SUBARU®

NUMBER 12-52-91

SERVICE BULLETIN

SUBJECT: RATTLING NOISE OF REAR GATE DOOR ON "L" SERIES STATION WAGONS

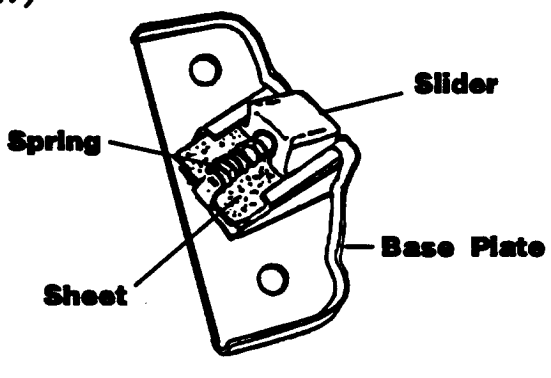
If you encounter a customer complaint of a rattling noise from the rear gate area it may be necessary to install a plastic sheet into each buffer assembly after eliminating other possibilities.

The part number for the sheet is 60109GA070, package quantity 1, and can be obtained through normal parts channels. The procedure will require two sheets, one for each buffer assembly.

1. Remove buffer assemblies from the vehicle.

Ensure if shims are removed, care is taken to keep them with the appropriate buffer assembly. It will be necessary to re-install them during re-assembly.

2. Depress spring towards slider and remove.

3. Remover slider from buffer base plate.

4. Insert sheet into buffer base plate.

5. Apply grease on sheet, Silicolube G-30, P/N 004404002 or equivalent is recommended.

6. Re-install buffer assembly and spring.

7. Re-install shim(s) during buffer installation, if necessary. Tighten the buffer mounting bolt to 5.4-9.3 Nm (0.55-0.95 Kg-m, 4.0-6.9 ft. lbs.)
